# **RED MOUNTAIN GOLD**

## **PROJECT DESCRIPTION SUPPLEMENTAL INFORMATION**

### **MARCH 2016**

Figure 1: Location of Project Components – Red Mountain Gold Project

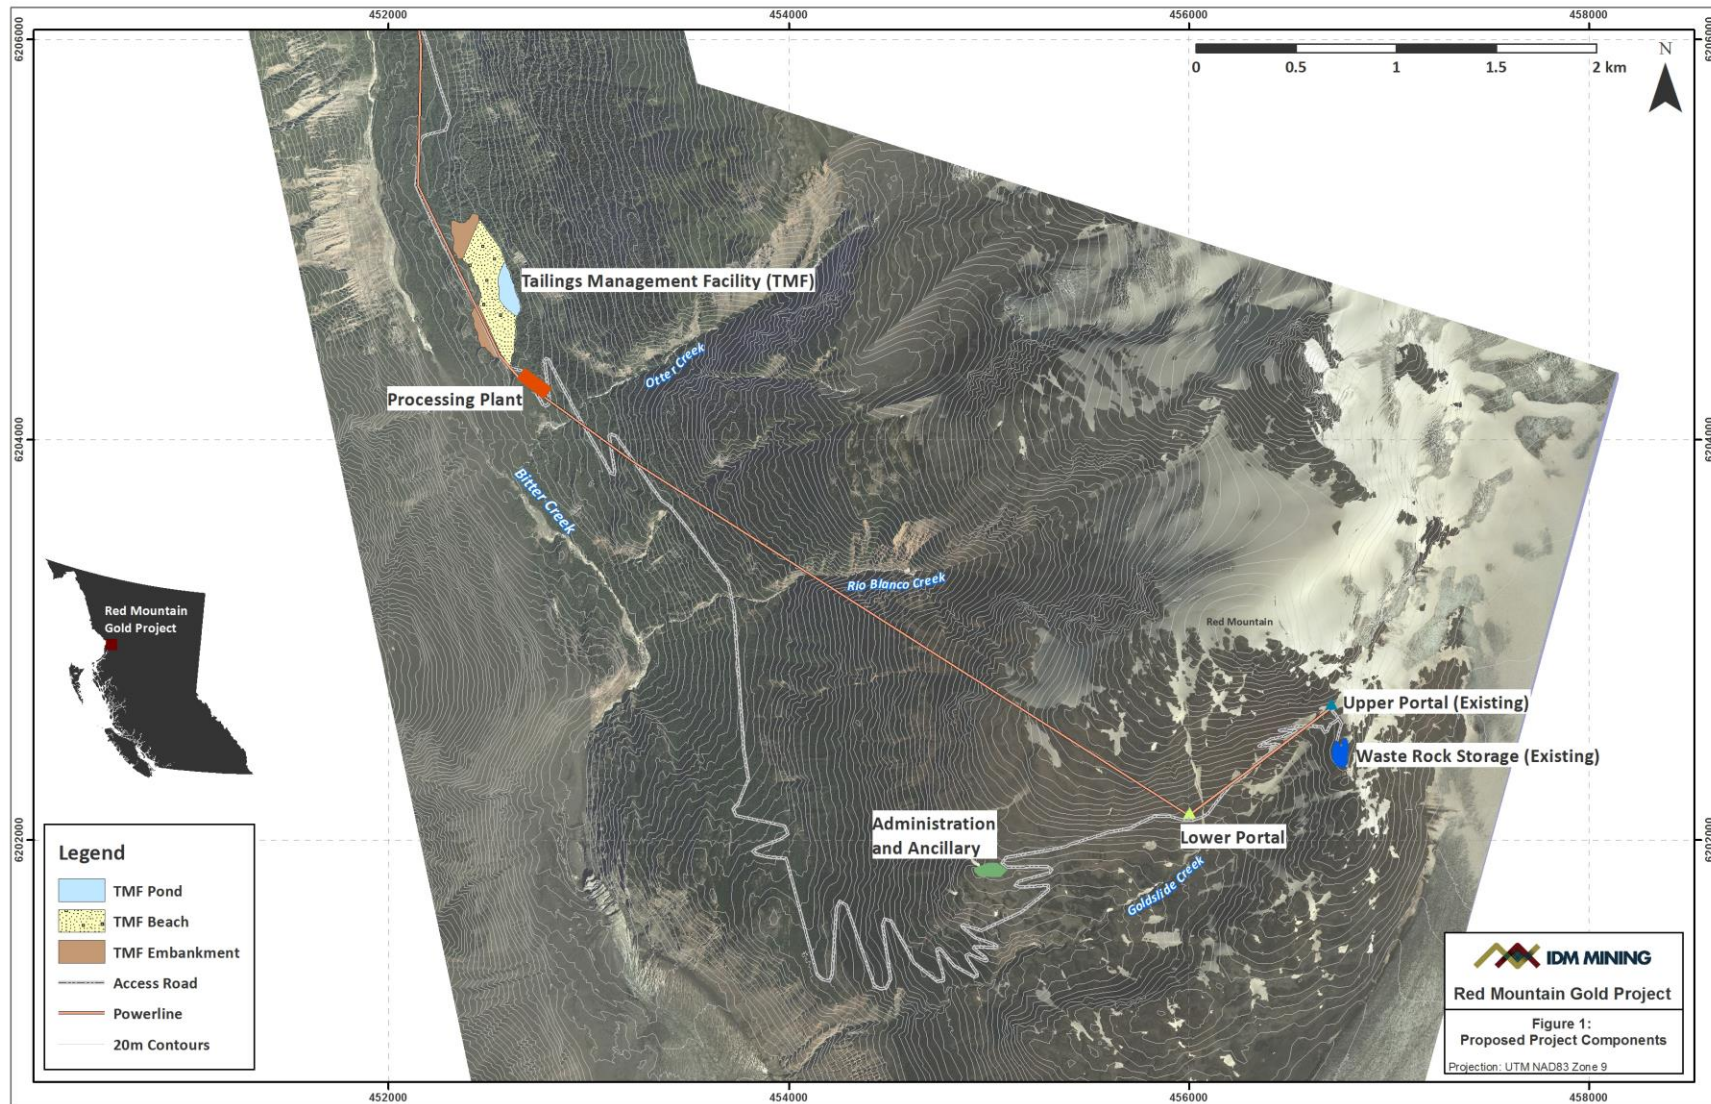
IDM Mining Ltd. (IDM) prepared and submitted the *Red Mountain Gold Project Description* to the BC Environmental Assessment Office (BC EAO) and the Canadian Environmental Assessment Agency in September 2015. The purpose of the Project Description is to provide an overview of the proposed Project, including the Project's location, regional context, environmental baseline conditions, potential effects of the Project on the environment, and proposed construction, operational, and decommissioning activities. The Project Description also includes an overview of proposed Project infrastructure components and their preliminary layout at the Project site. IDM wishes to amend the location of the proposed mineral processing facility and tailings management facility (TMF) from the location currently described in the Project Description (in the alpine area near Goldslide Creek) to a new location called Bromley Humps, which is three kilometers to the north, near Otter Creek.

IDM has prepared this document to supplement the September 2015 Project Description and provide an overview of the updated project layout and any implications this amendment would have on the information provided in the Project Description. The following sections and figure have minor revisions applied as a result of the change in the mineral processing facility and TMF's location. IDM has provided the revised figure and wording for each section below.
